ALERT SERVICE BULLETIN

505-21-25
30 August 2021

MODEL AFFECTED: 505

SUBJECT: RIGHT HAND LATERAL CENTER OF GRAVITY,
REDUCTION OF

Figure 1 – Instrument Panel and Decal Details

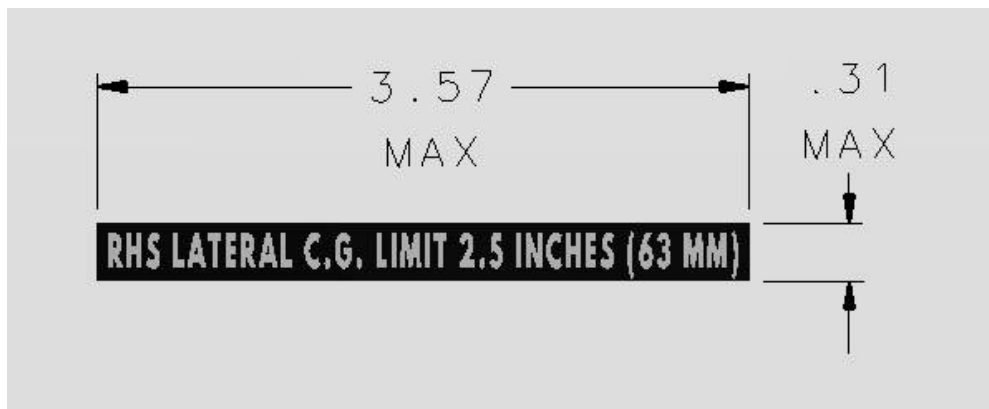
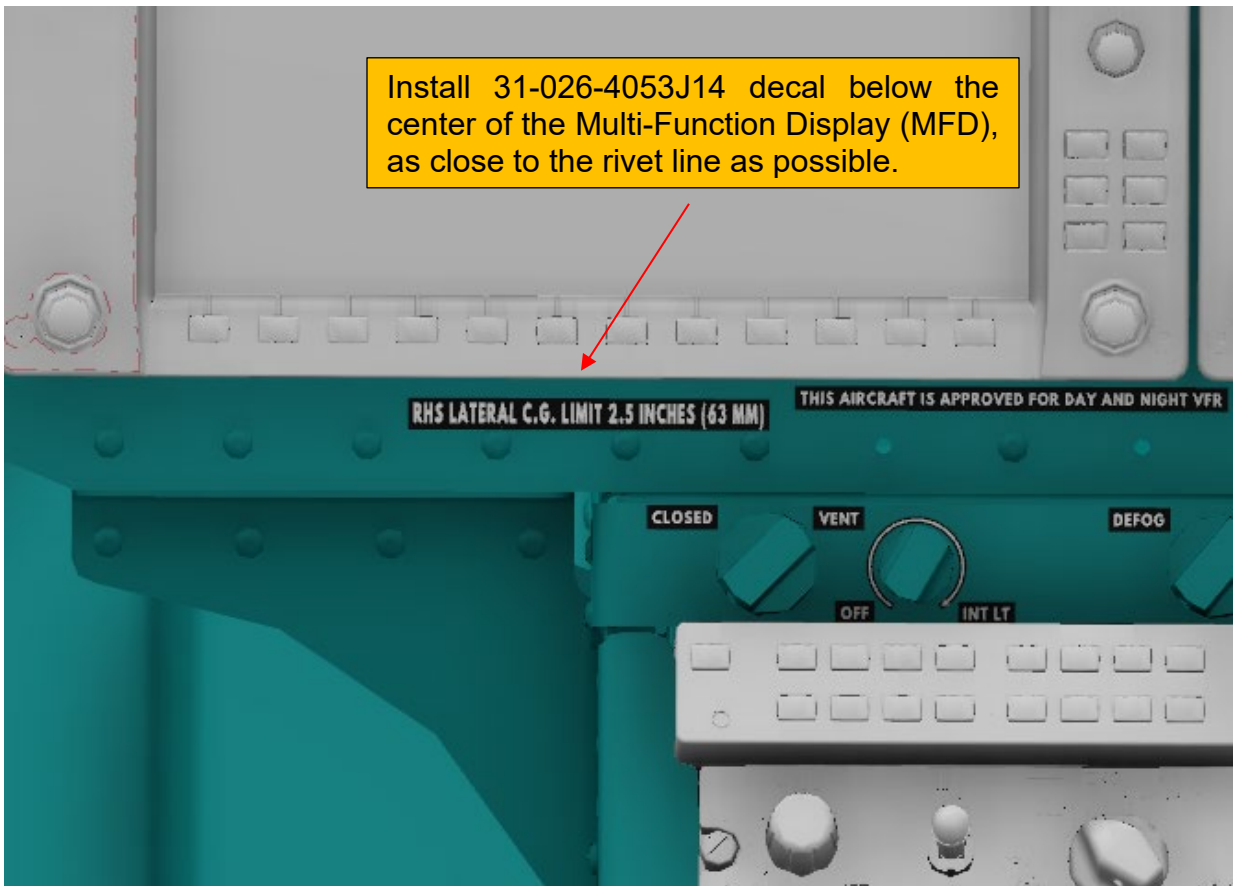
1. Prepare the helicopter for maintenance.
2. Gain access to the left side of the cockpit (Zone 220), ([DMC-505-A-06-30-00-00A-030A-A](#)).
3. Identify location on instrument panel below the Multi-Function Display (MFD) where decal 31-026-4053J14 is to be installed (Figure 1).

- (1) Thoroughly wipe the surface with a clean cloth (C-486) or equivalent dampened with aliphatic naphtha (C-305).
- (2) Install decal 31-026-4053J14 on instrument panel as shown.
 - (a) Seal the edges of the decal (C-349) (BHT-ALL-SPM, Chapter 8).

1. BHT-505-FM-1 Rev. 7 applicable 65011 through 65169, 65171 through 65300
2. BHT-505-FM-2 Rev. 1 applicable 65170, 65301 and subsequent.
3. The decal can be locally manufactured using lettering of white color No. 17875 on black background color No. 17038. Characters to be 14-point Spartan black font, color per AMS-STD-595. The text should be in capital letters as detailed in (Figure 1).
